ADDENDUM NUMBER ONE

Indiana University
Launch Accelerator for Biosciences
1302 Indiana Ave.
Indianapolis, IN 46202

Addendum Dated: OCT 16, 2025

IU Project #: 20250072
BSALS Project #: 00360481

C500

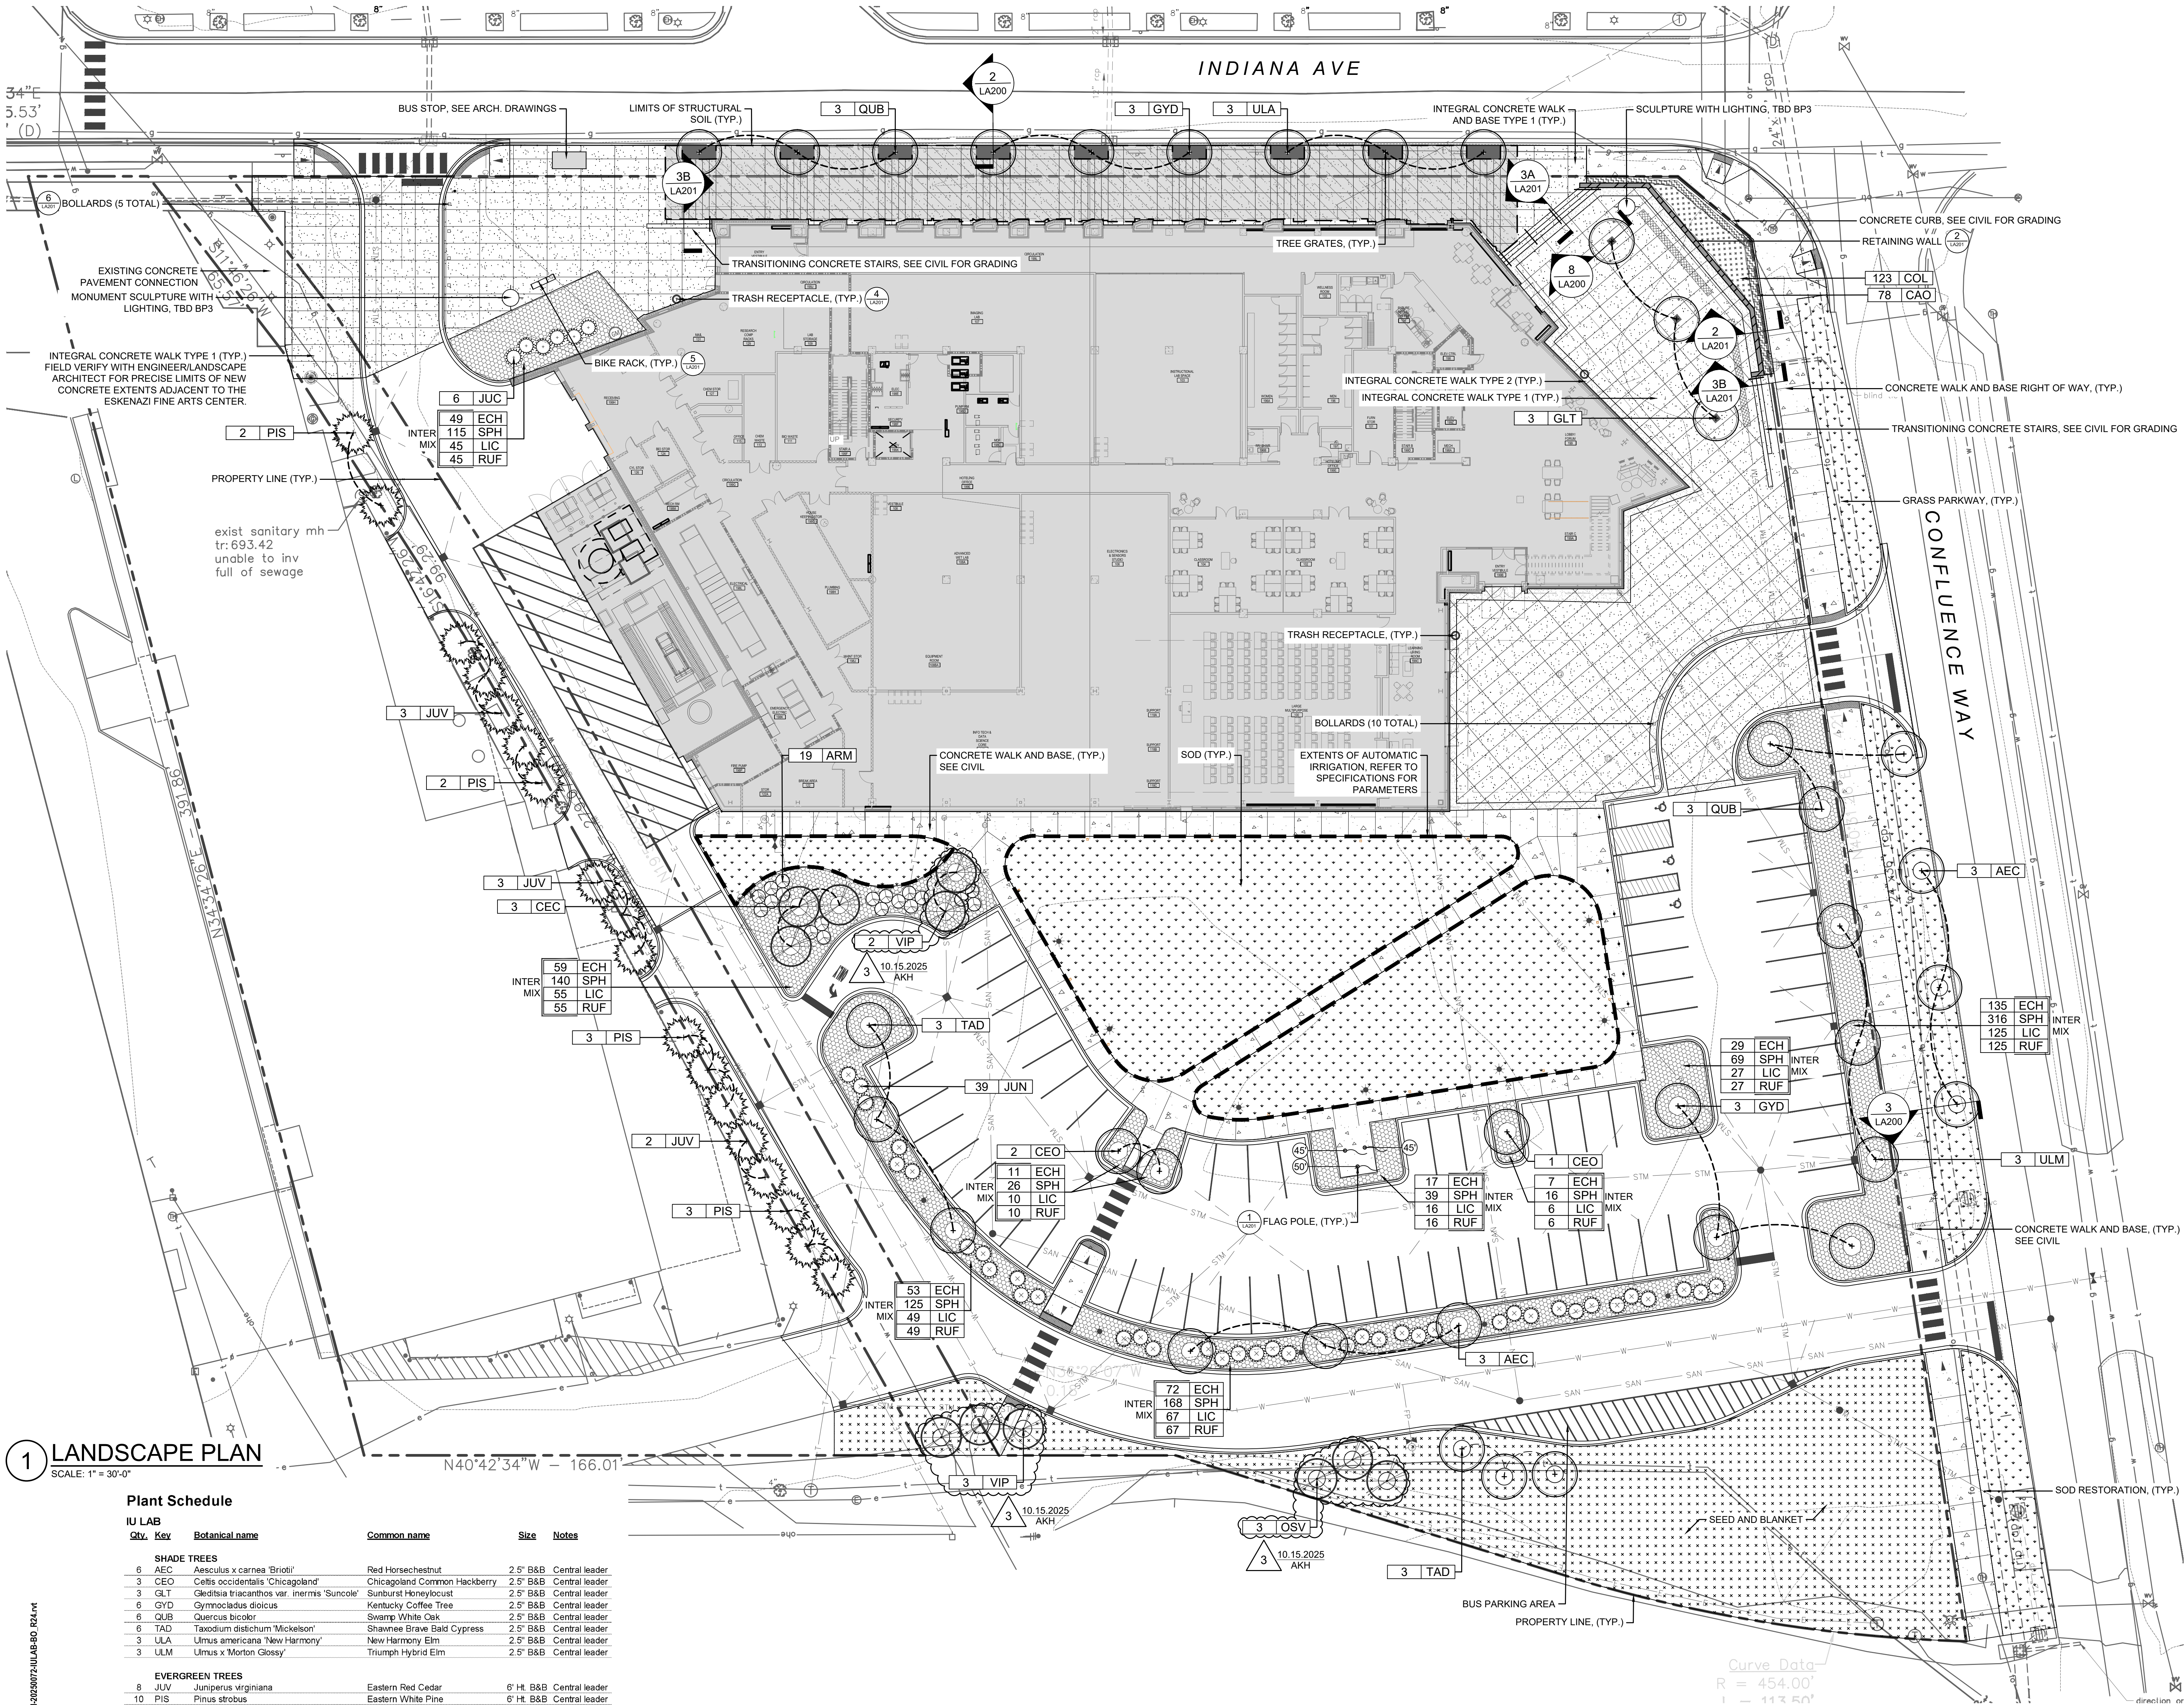
6. **Sheet C420:**
 - a. Revise the BMP detail as shown on the attached revised sheet C420.
7. **Sheet C500:**
 - a. Revise the MEP yard area layout as shown on the attached revised sheet C500.

LA100

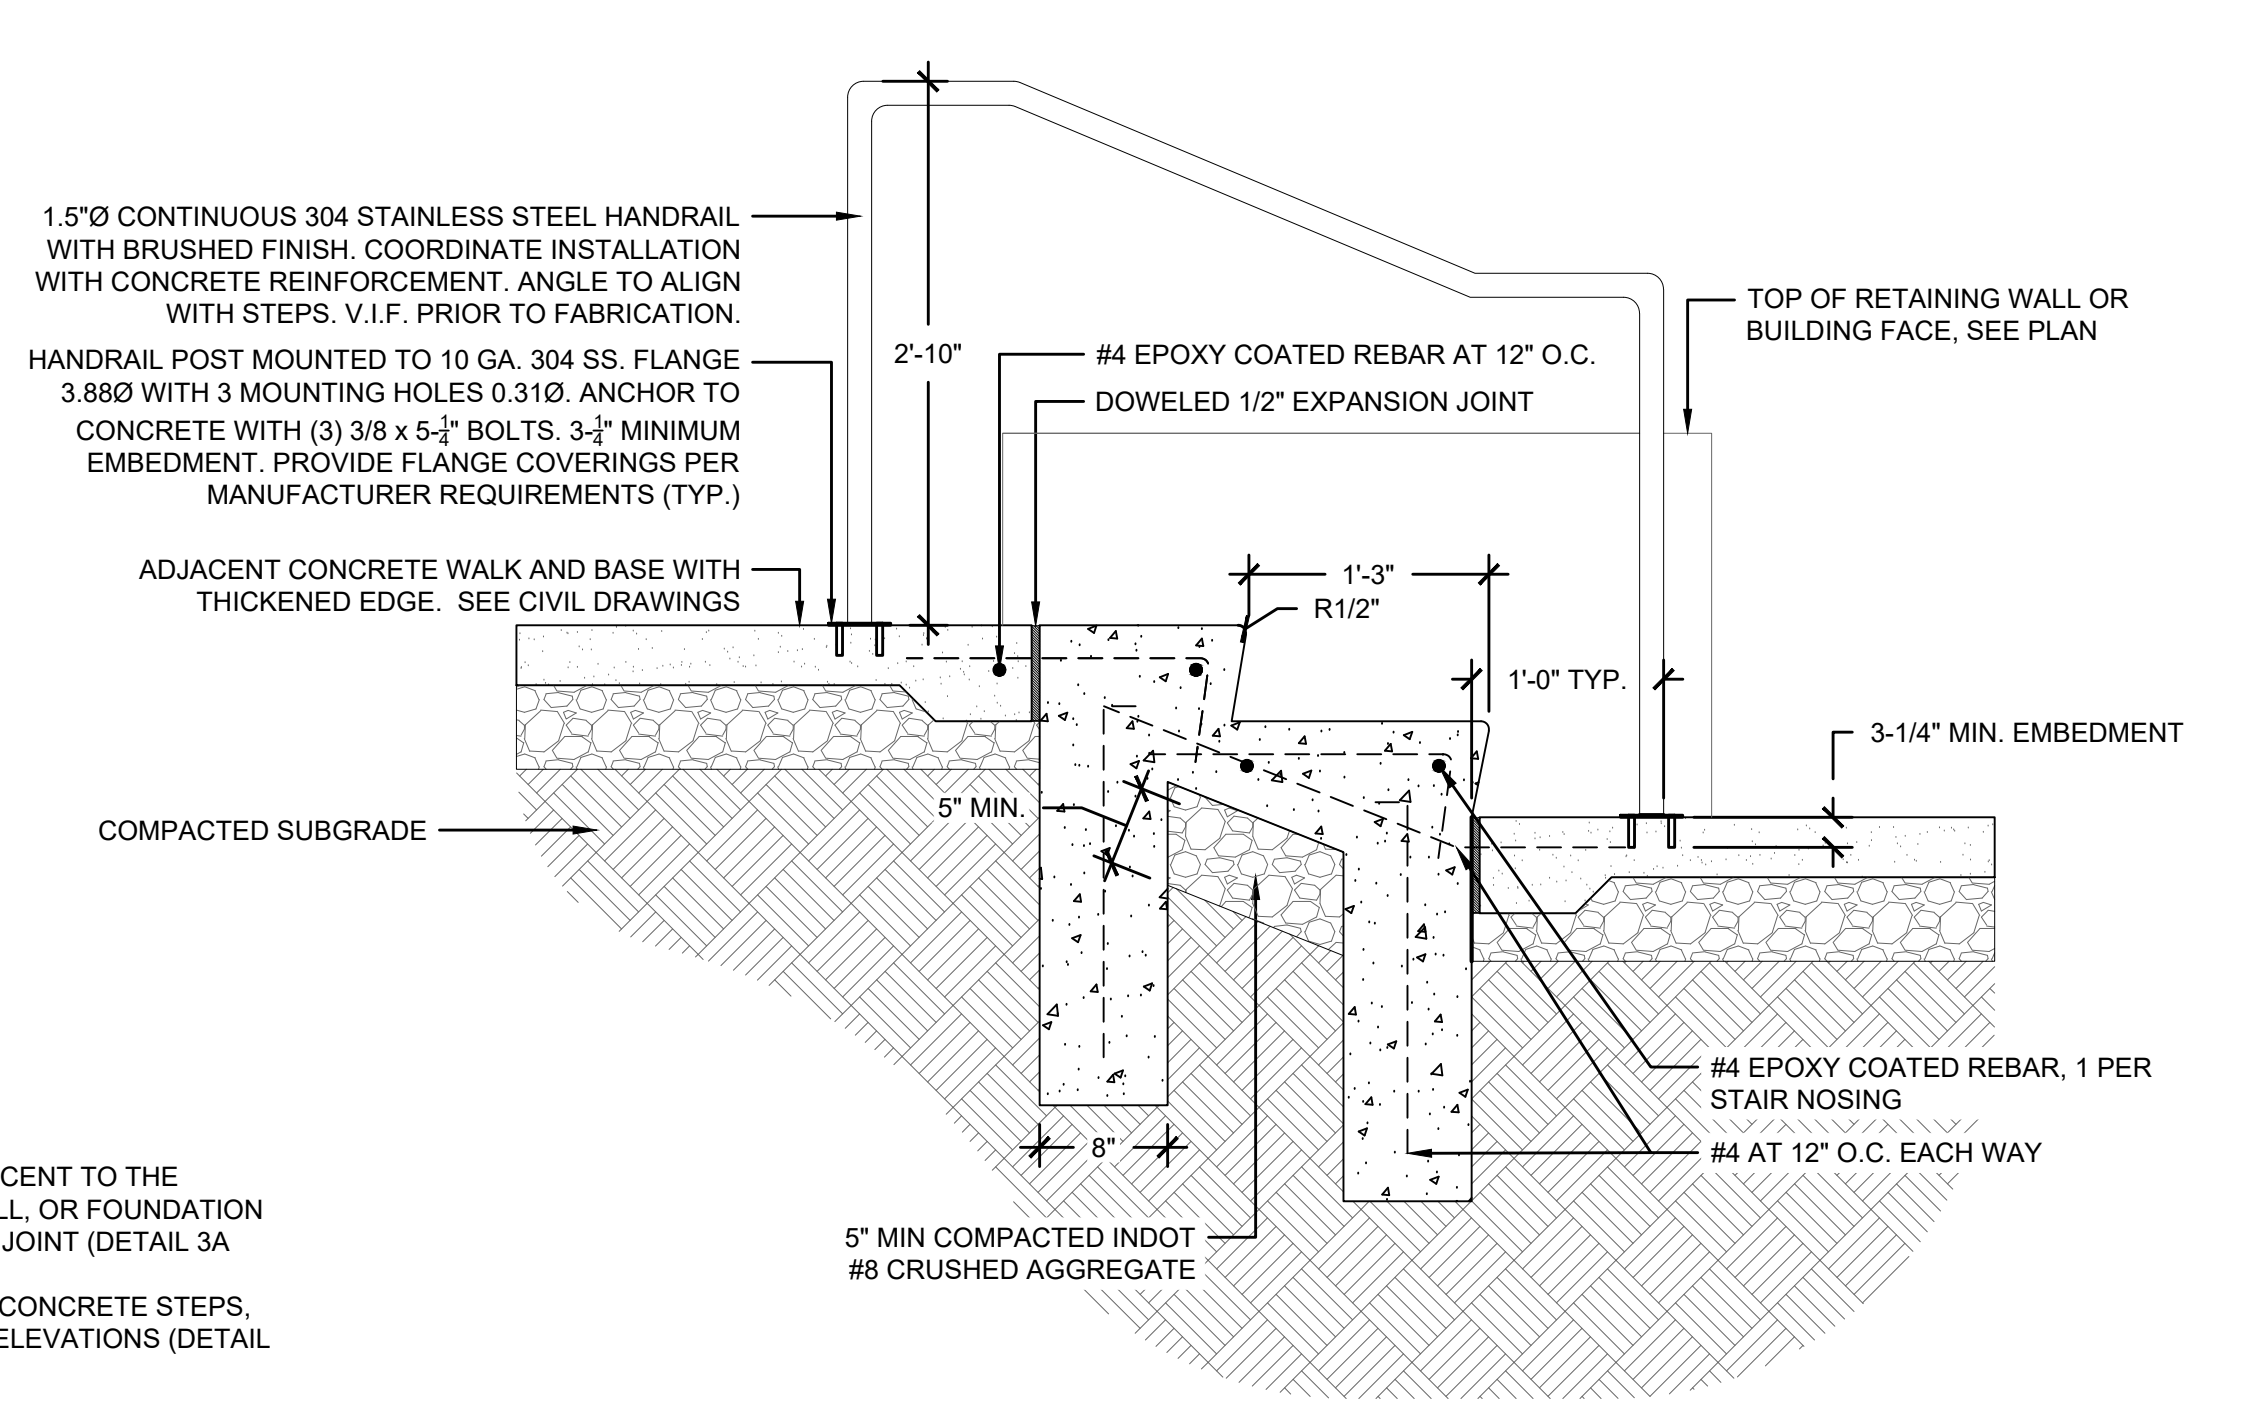
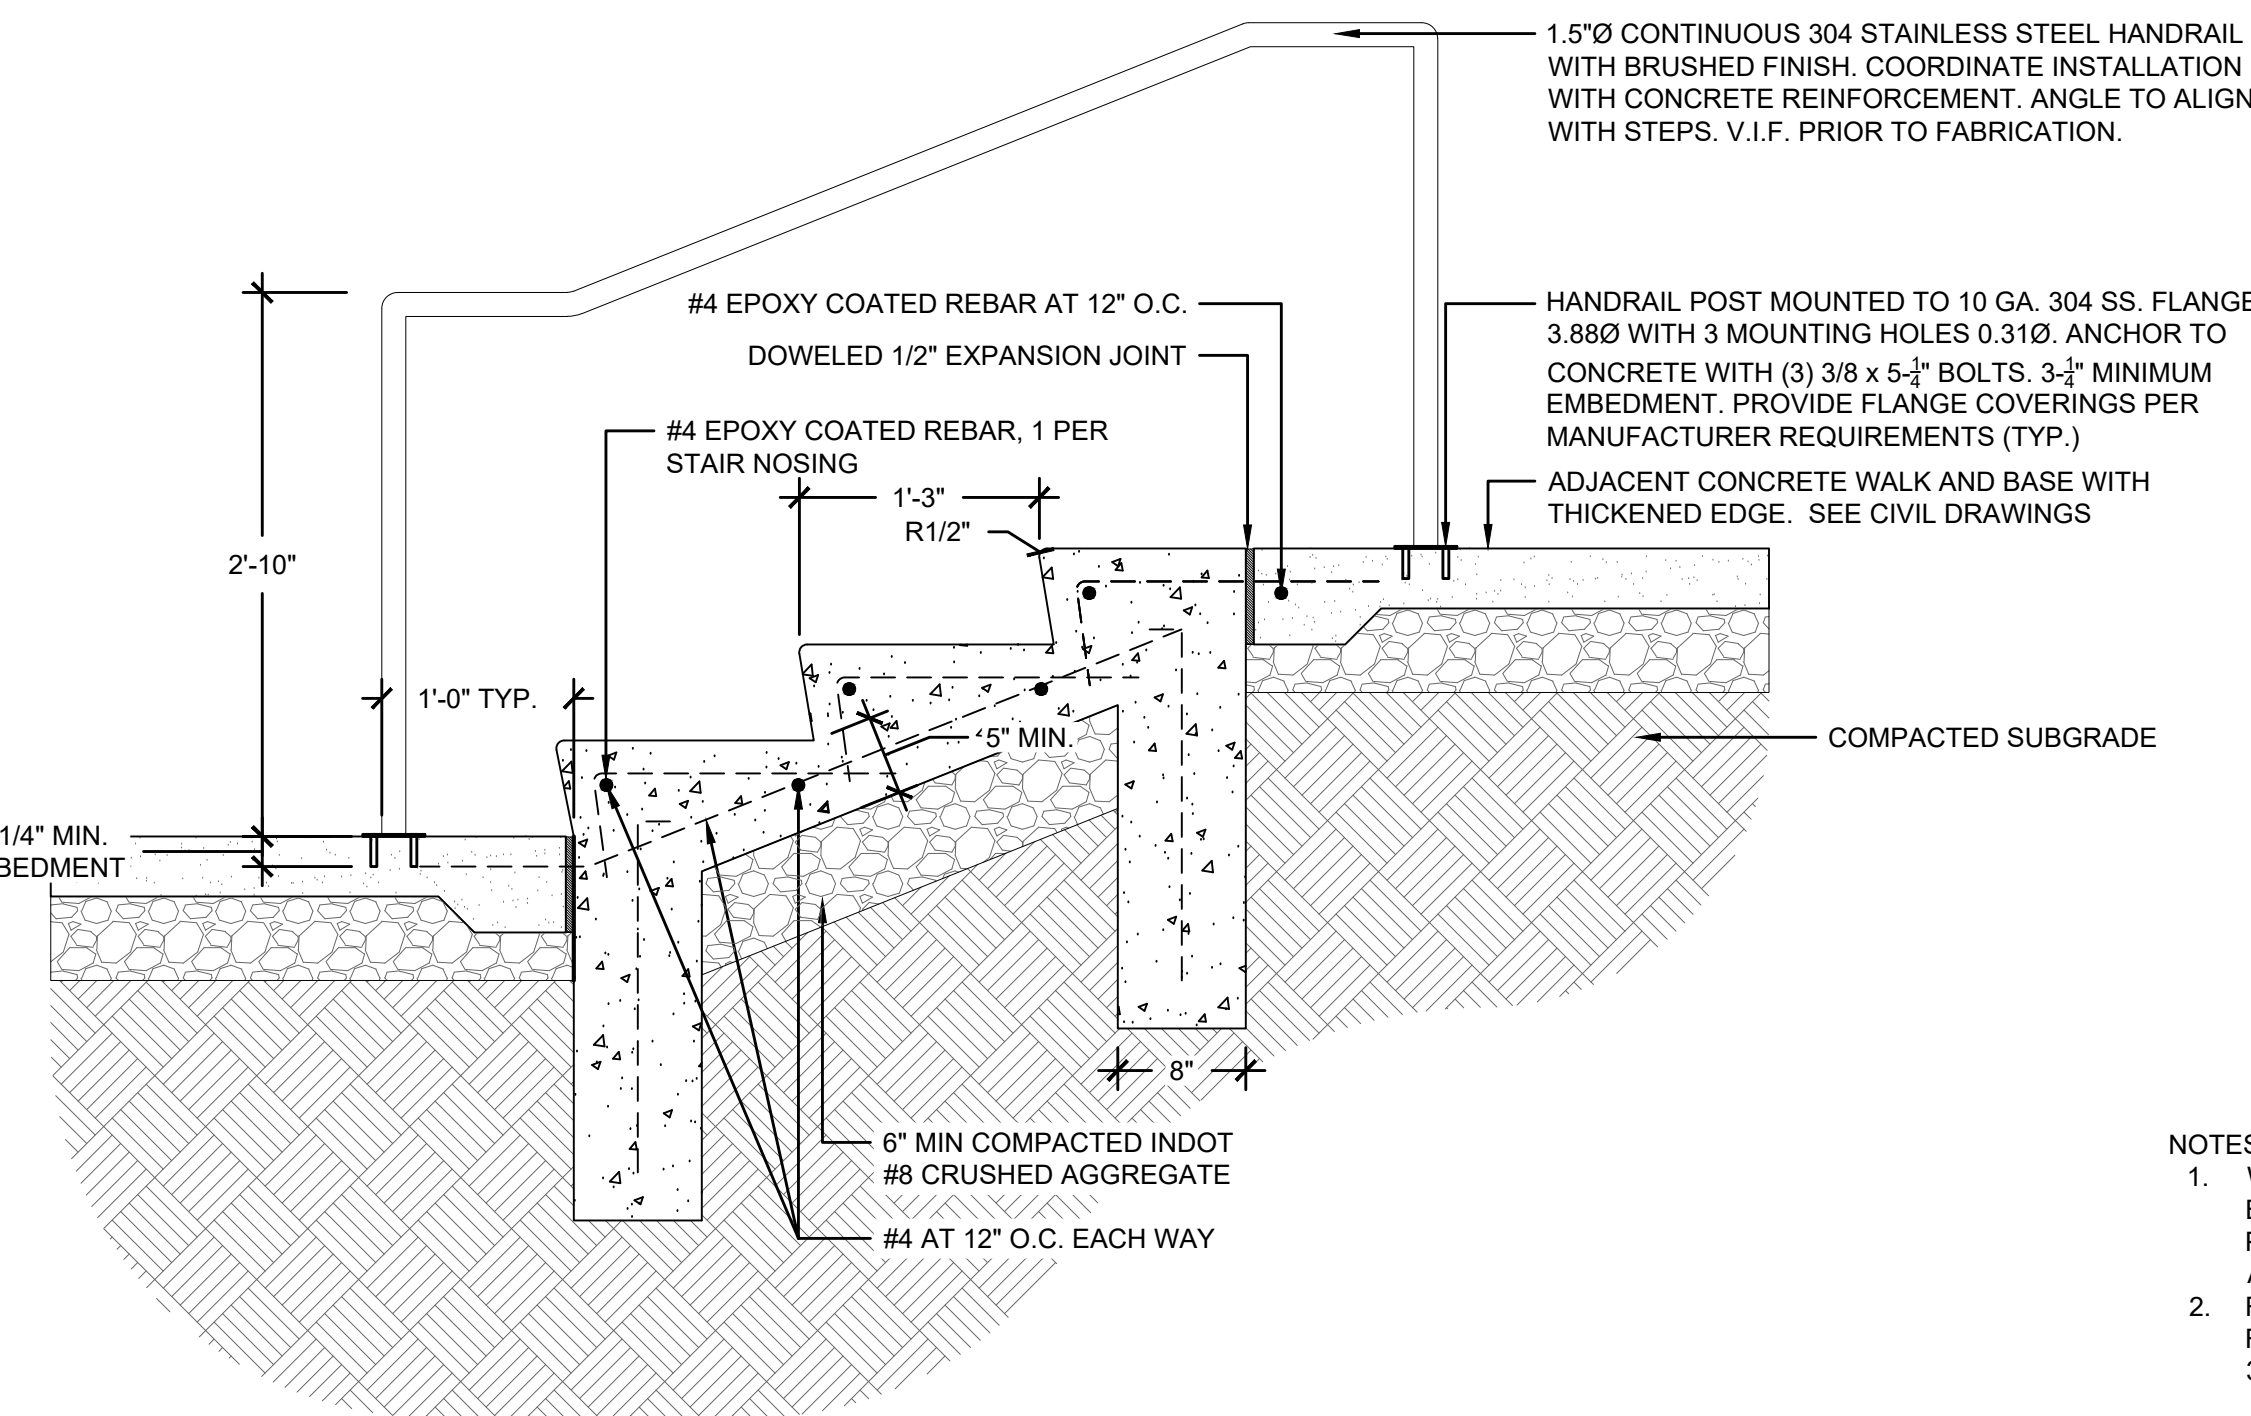
8. **Sheet LA100:**
 - a. Revised quantity of ornamental trees in Plant Schedule and Landscape Plan.
9. **Sheet LA201:**
 - a. Revised Trash Receptacle Detail based on new product selection.
